**UNITED STATES OF AMERICA
BEFORE THE
FEDERAL ENERGY REGULATORY COMMISSION**

**Rockies Express Pipeline, LLC : Docket No. CP07-208-000
 : CP07-208-001**

**REQUEST FOR REHEARING
SUBMITTED ON BEHALF OF
THE OHIO POWER SITING BOARD**

June 30, 2008

Figure 3.4.9-1
Big Darby Creek Route Alternative

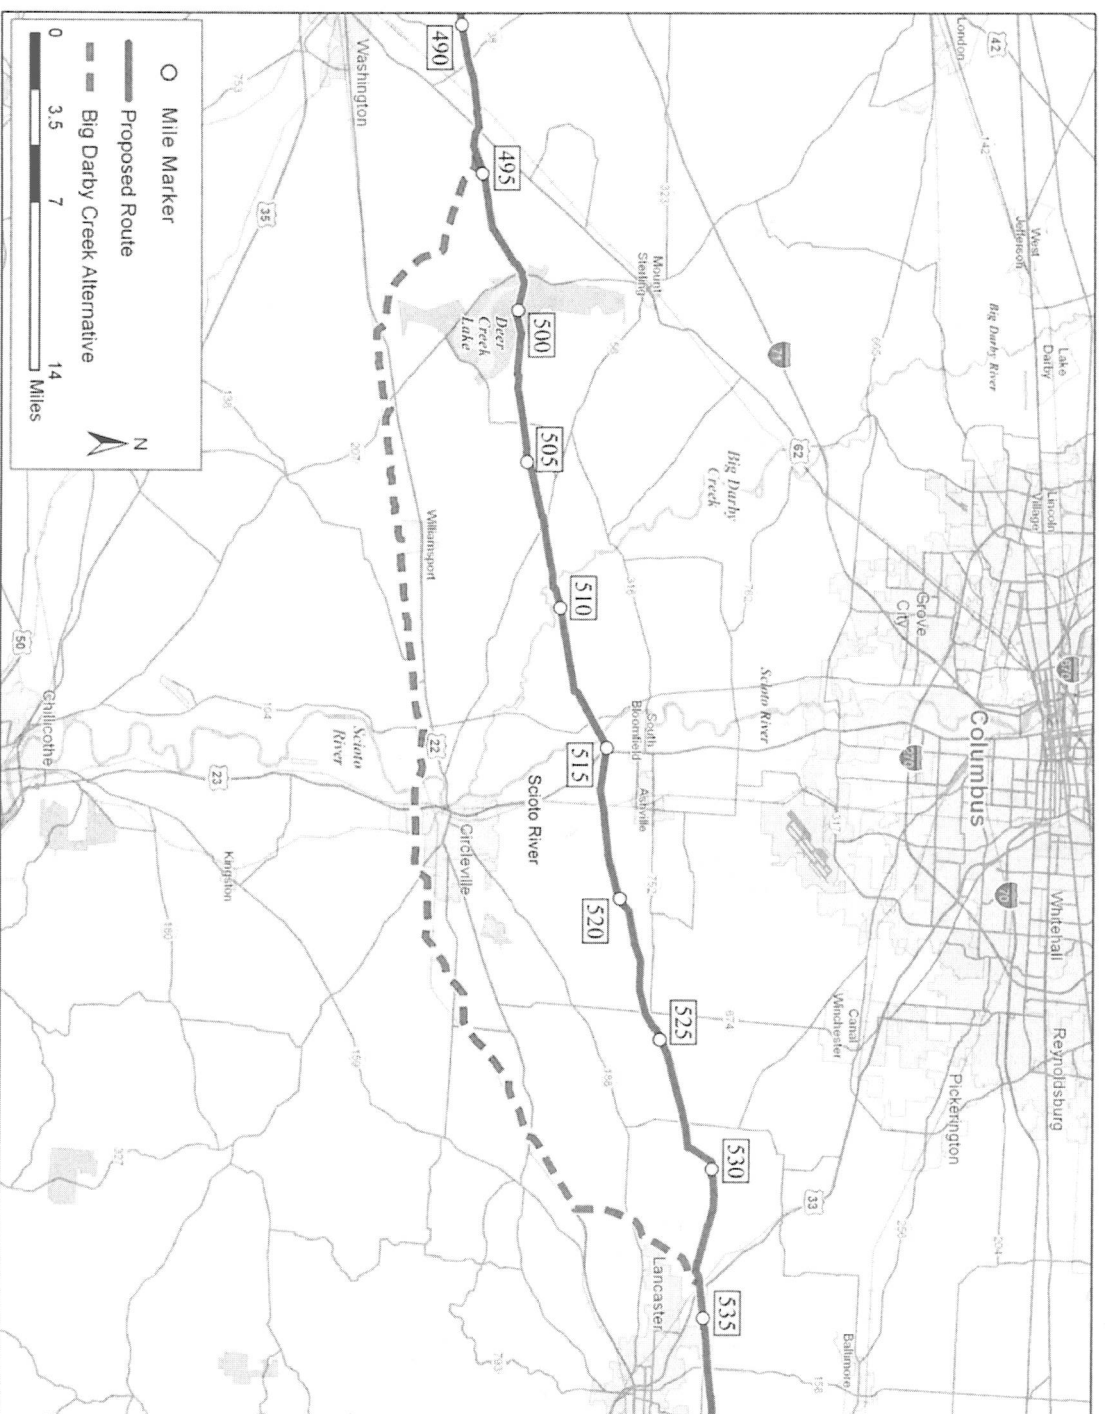
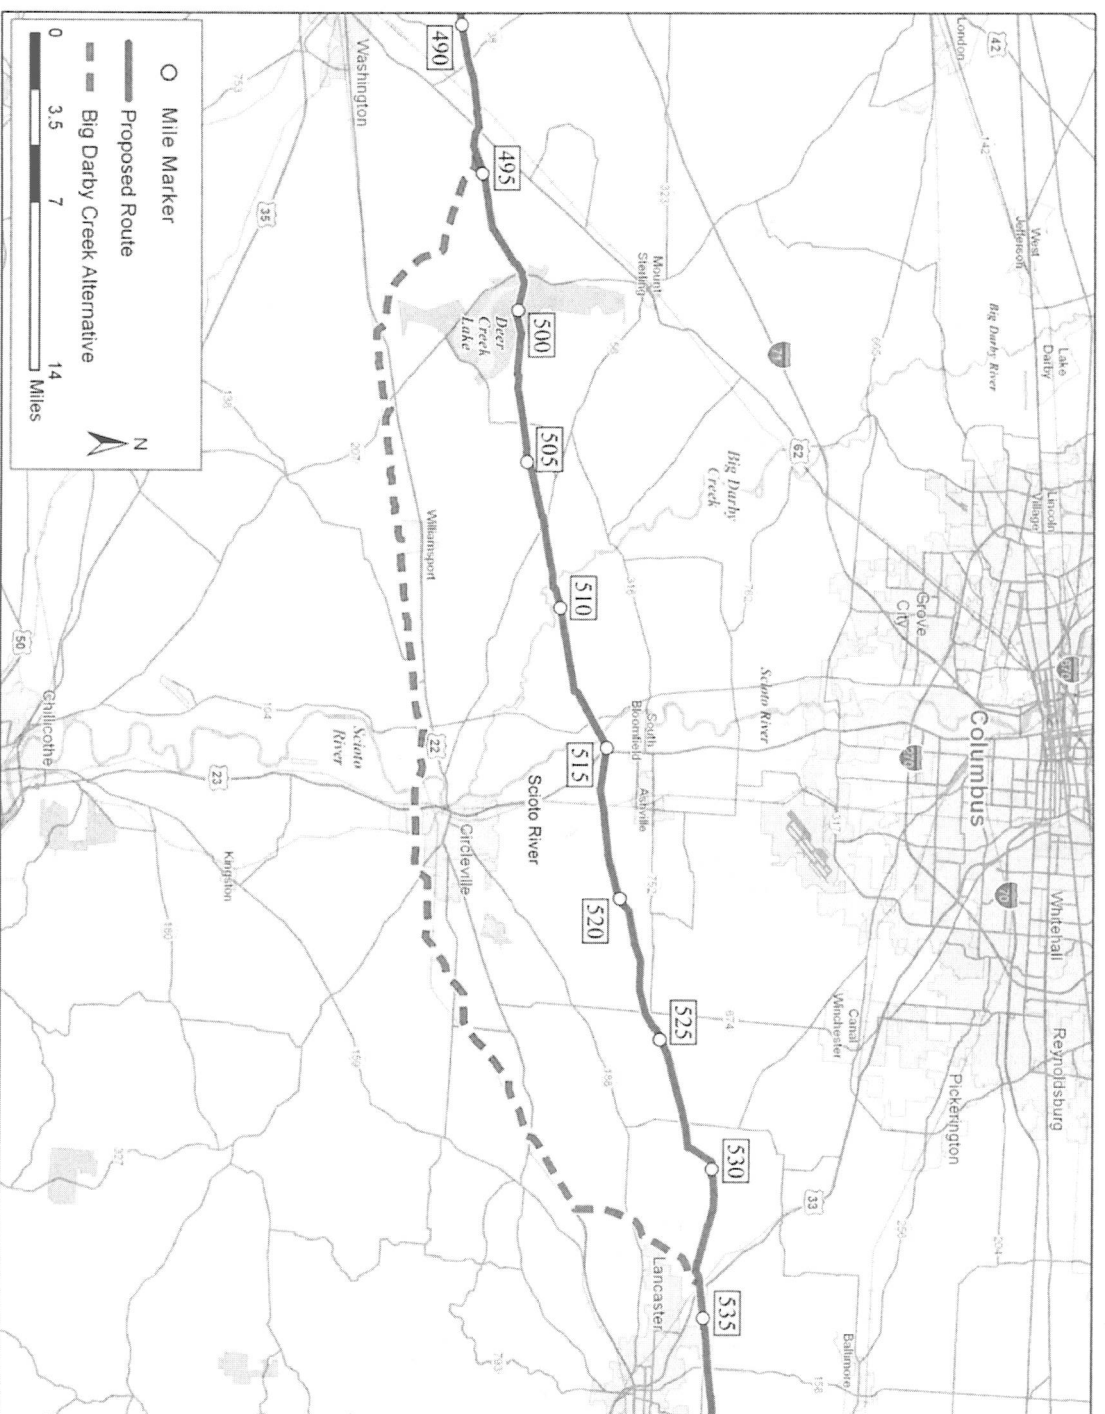
1. The May 30, 2008 Order Issuing Certificate erred in failing to accept the OPSB's proposed alternative route for crossing the Big Darby Creek State and National Scenic River. (See Attachment A, Big Darby Creek Alternate)
2. The May 30, 2008 Order Issuing Certificate erred in failing to accept the OPSB's proposed alternative route for crossing the Little Miami State and National Scenic River. (See Attachment B, Little Miami River Alternate)
3. The May 20, 2008 Order Issuing Certificate erred by failing to adequately address contingency plans (frac-out contingency plans) that should be in place for the Big Darby, Little Miami and other Ohio water crossings in the event the proposed horizontal directional drilling (HDD) or other crossings permitted by the May 30, 2008 Order are not safely completed.

In the case of the Big Darby, there is a reasonable alternative that would allow Rockies Express to completely avoid this body of water. The OPSB continues to believe that this is an exceptional opportunity to minimize the potential for degradation to one of Ohio's most significant biological systems.

(emphasis added). This letter from the ODNr stresses that the geology at the proposed Big Darby crossing may serve to frustrate HDD success. If the HDD project at the Big Darby is defective, serious ecological ramifications could result. OPSB continues to have significant concerns about the risk of HDD failure or frac-out and because of these significant concerns, the OPSB requests that the Commission direct Rockies Express to avoid the Big Darby altogether.

The OPSB, in this request for rehearing, implores the Commission not to gamble with the Big Darby where a reasonable alternative route exists, as evidenced by the

Commission's Final EIS. Table 3.4.9-1 of the Final EIS, lays out an environmental comparison of the project route and the alternative route recommended by the OPSB. The Commission found that the alternative route adds only 5.8 miles to the project route, "maximizes length along existing rights-of-way and crosses one less waterbody," and avoids more forested and residential land than the project route.⁴ Where the project route crosses 2.2 miles of Deer Creek State Park and is projected to cause "long term impacts to forested areas," (Final EIS, 3-31), the Commission states that the alternative avoids the state park altogether. The OPSB concurs with these assessments and is left to wonder why the project route was ultimately approved.

In explanation, the Final EIS stated, "[a] successful HDD would not disturb the banks, vegetation, or water quality of the creek, and would protect the scenic values of the river." (Final EIS, 3-31) (emphasis added). To be sure, avoiding disturbance of the banks, vegetation, water quality and scenic value of the Big Darby is a worthy goal. However, an HDD failure could have disastrous effect on these elements of the Big Darby that so many have been working to protect. On rehearing, the Commission should ensure that this goal is met by approving the reasonable alternative route and missing this prized natural resource altogether.
